January 2, 2020

TO: Warrenton Planning Commission
FROM: Kevin A. Cronin, AICP, Assistant City Manager/Community Development Director
RE: Site Design Review Application (File: SDR 19-7) | Eagle Landing Apartments

SITE PLAN
EAGLES LANDING APARTMENTS
 WARRENTON, OREGON

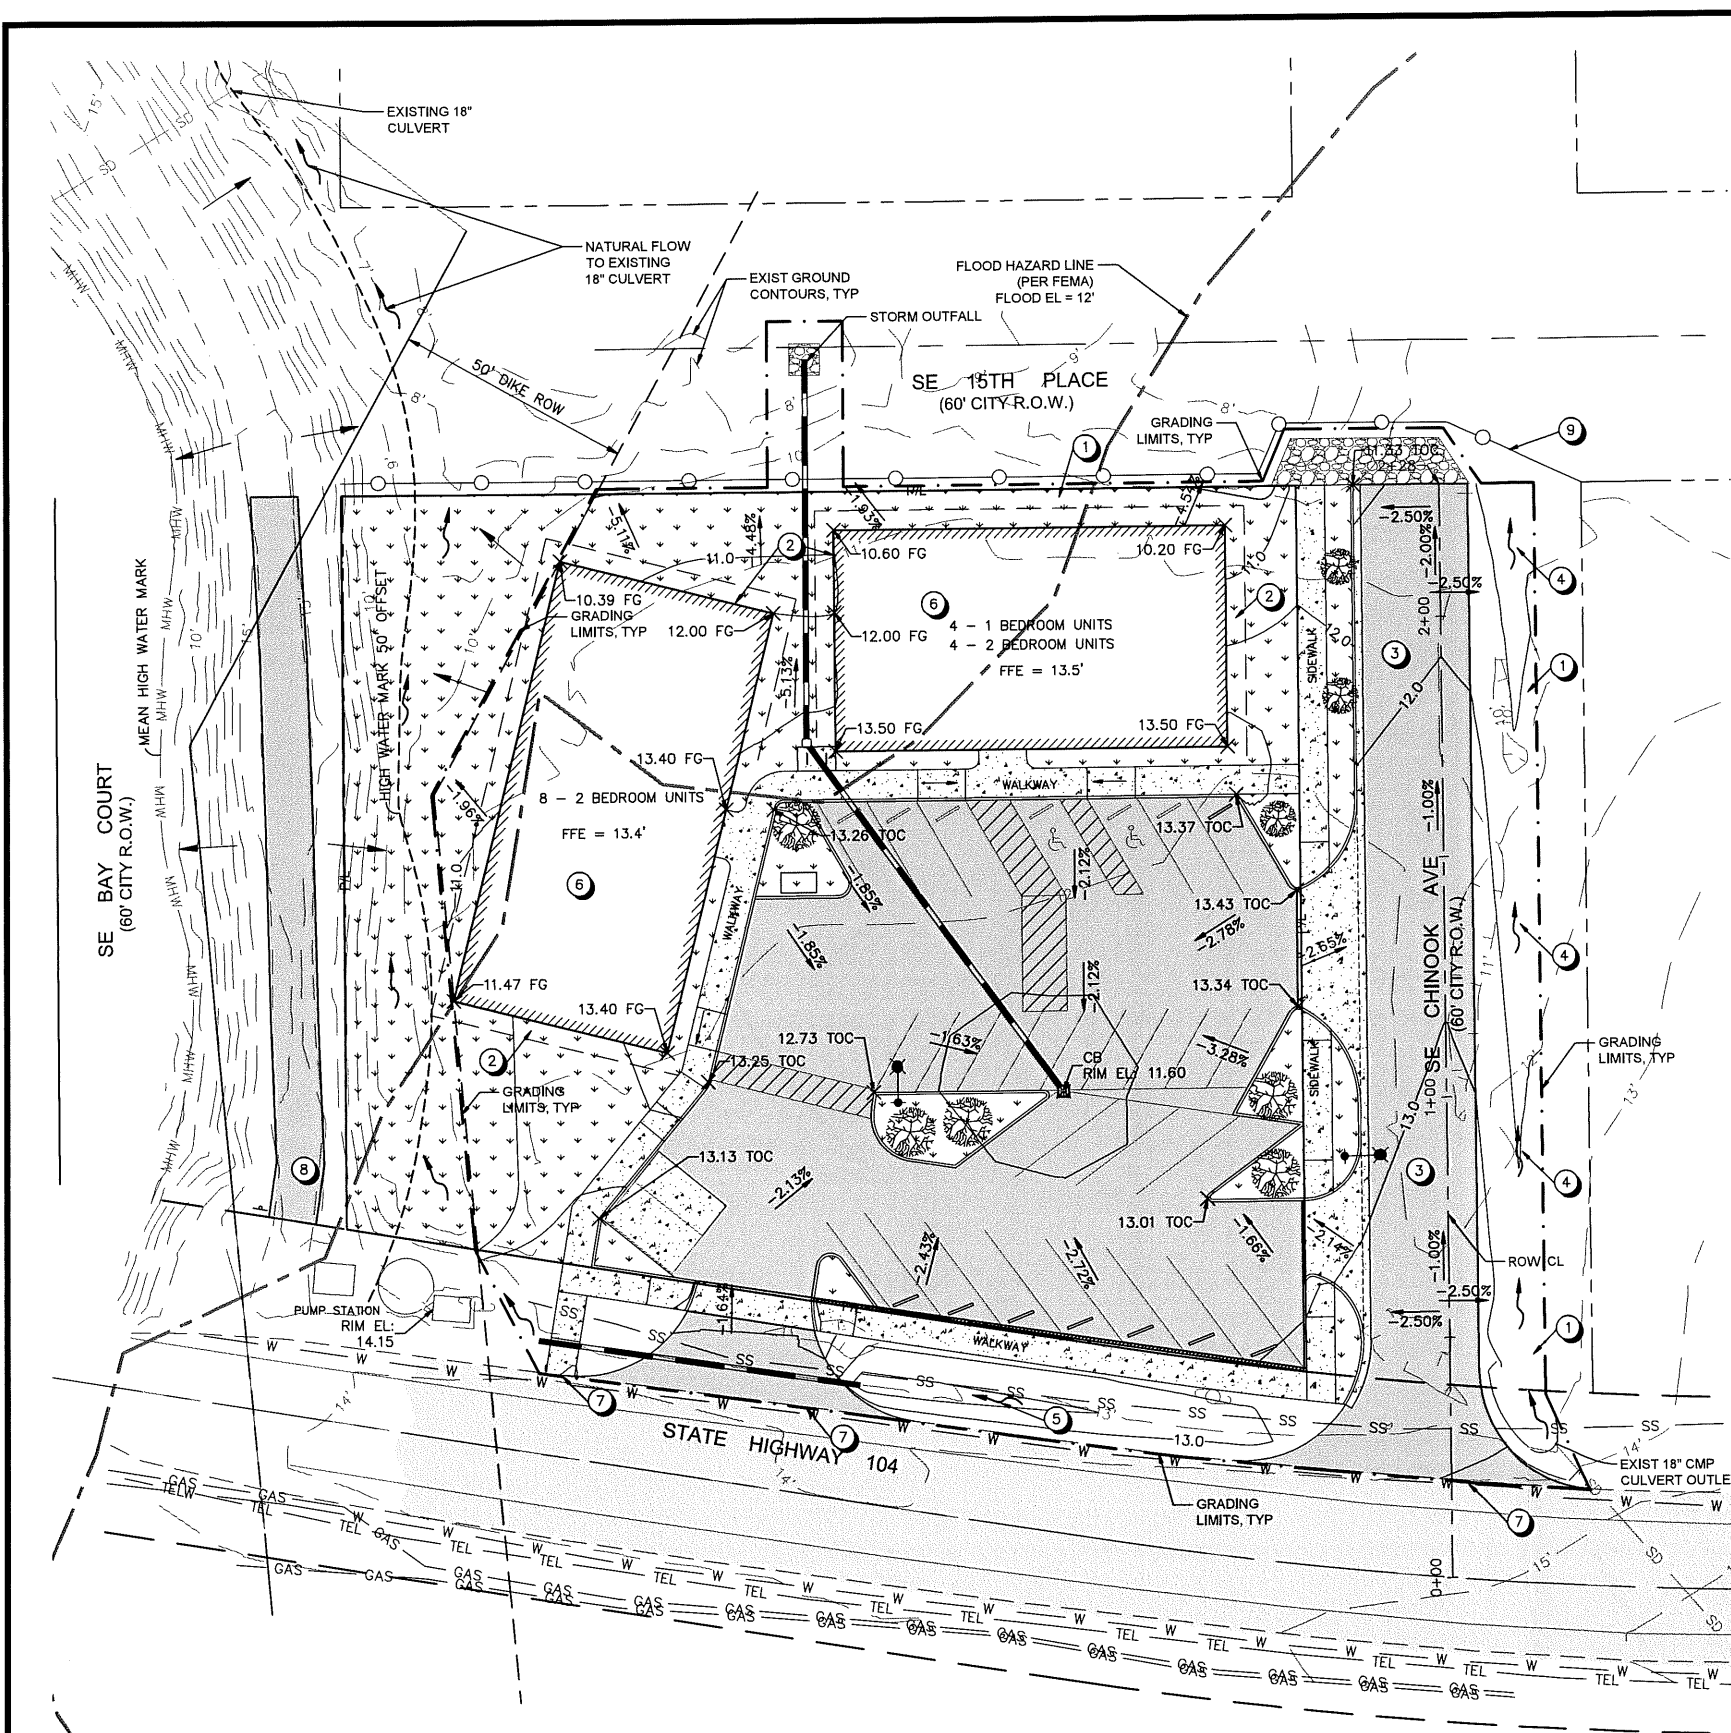
Staff finding: Based on a review of the site plan, there are no materials proposed within the clearance areas at the *property line* boundary. The proposed buildings do not appear to be within the vision clearance area. Standard is met.

Staff finding: The proposed site plan has a thermoplastic crosswalk from each driveway location to each building that as sidewalk around the perimeter. In addition, the Skipanon River Trail is proposed for asphalt paving to the property line and installation of a trail sign. A sidewalk is proposed on Spur 104 and the new public street. However, there are no street improvements proposed at the platted street toward the back of the property. See conditions of approval.

LANDSCAPING PLAN
 EAGLES LANDING APARTMENTS
 WARRENTON, OREGON

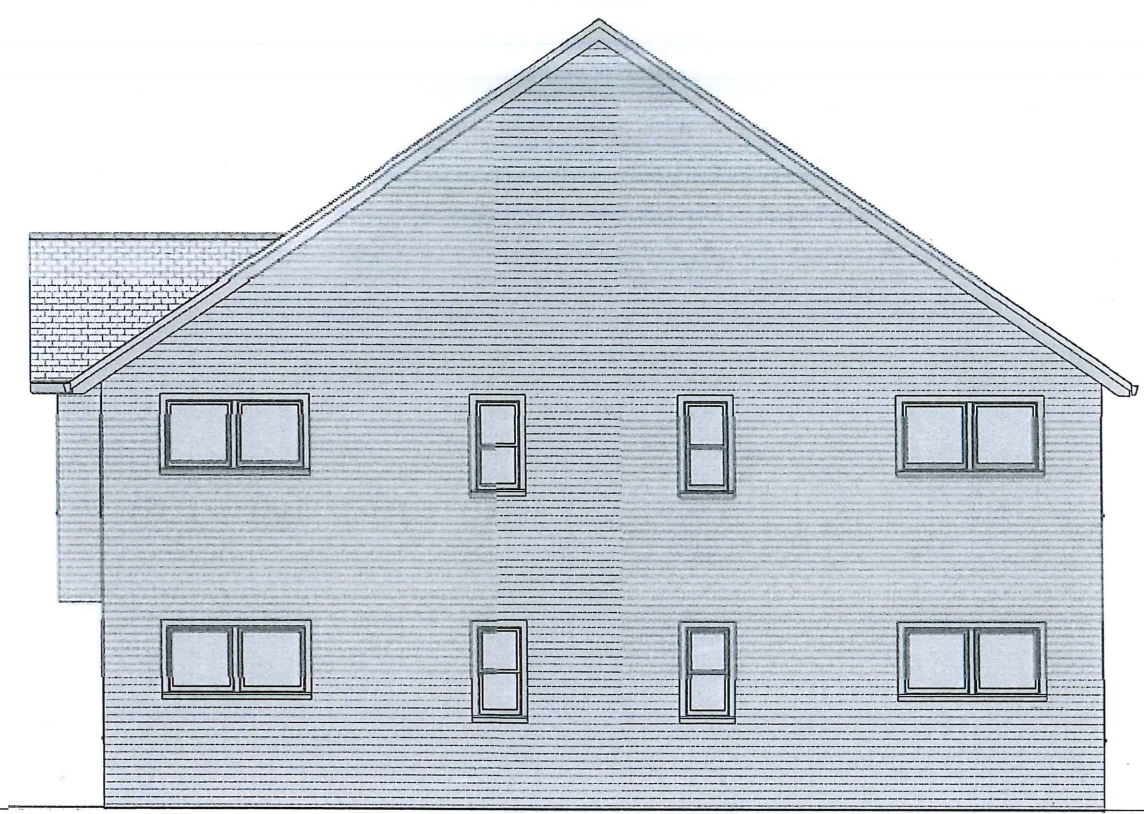
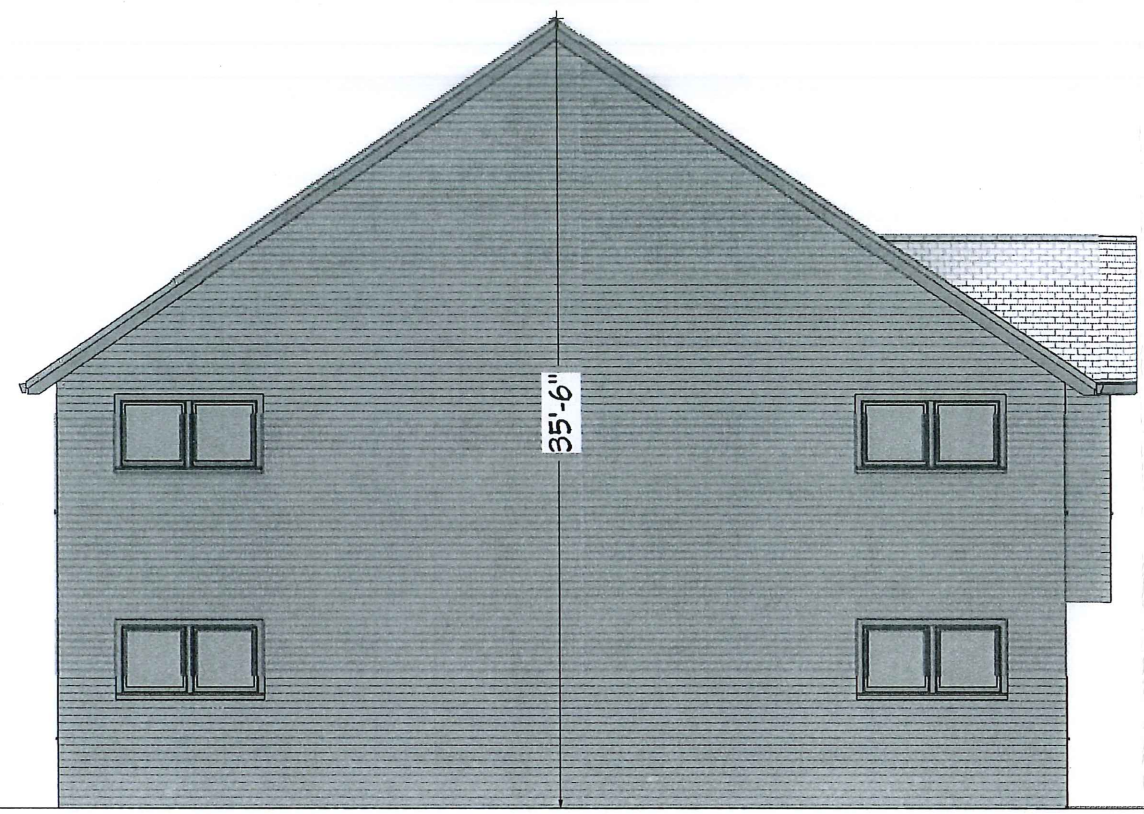
Staff finding: There is no outside sales or storage being proposed. A sign permit will be applied for at a later date. According to the proposed landscaping plan, there is no visual buffer of evergreen landscaping. This standard applies since the project is adjacent to residential zones (R10). The proposal includes off street parking but does NOT include a design to accommodate garages or carports to satisfy the standard. All other standards are addressed below or do not apply. See conditions of approval.

Staff finding: The site does have naturally occurring vegetation around the site. However, most of this vegetation encroaches on the proposed development and will need to be removed and replaced as a result of construction. The proposed landscaping has categories of plantings but does not specify the species. Specific landscaping materials will be required at building permit stage to comply with the native vegetation standards. The proposed groundcover meets the standard. At 33%, the site far exceeds the 20% minimum standard for residential uses. Removal of all non native species within the construction envelope is also required. See conditions of approval.

EAST BUILDING

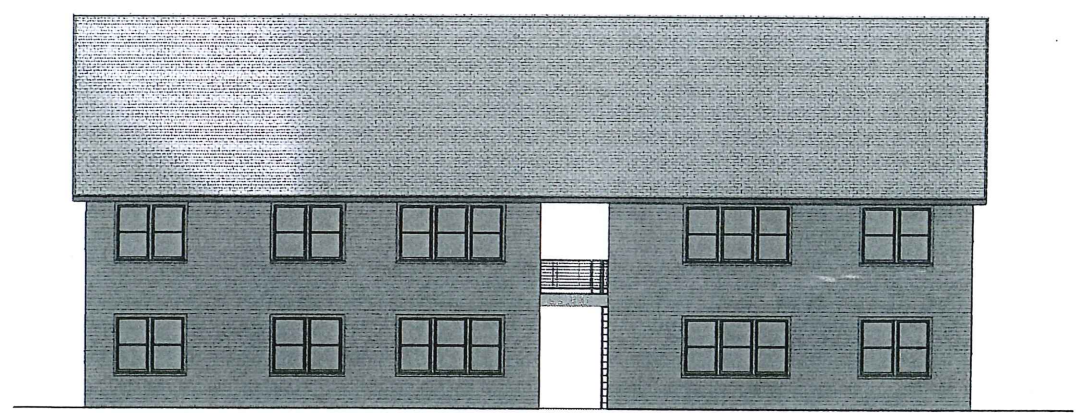
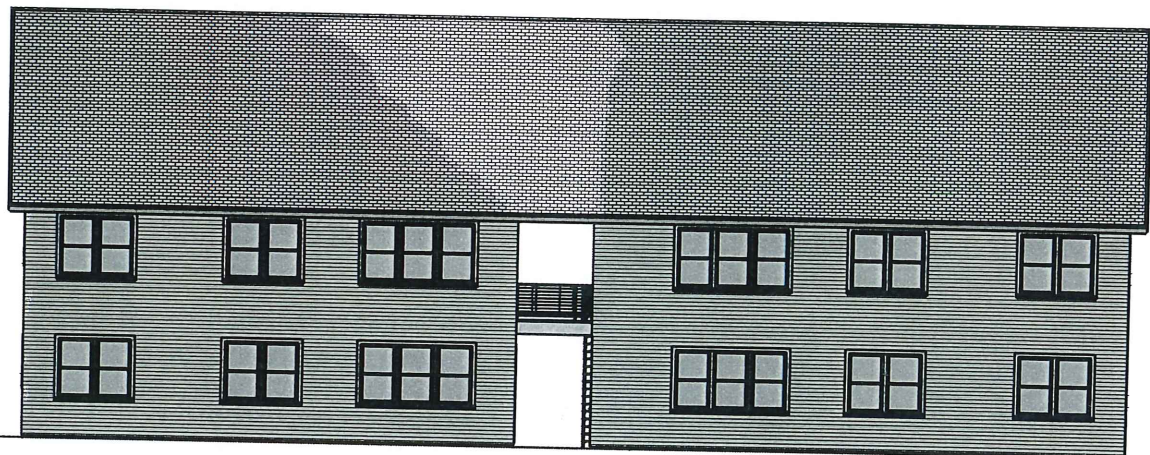
The proposed height of the new buildings will not exceed the maximum height standard. Based on a review of the elevations, the glazing standard appears to be met although the buildings are substantially setback from the street. However, compliance with the entry door standard cannot be ascertained. It appears the design uses an open stairwell to access each unit as opposed to one main entry point with a distinguished front door. The Commission will need to make findings to support the current design. Otherwise, a revised design will be required.
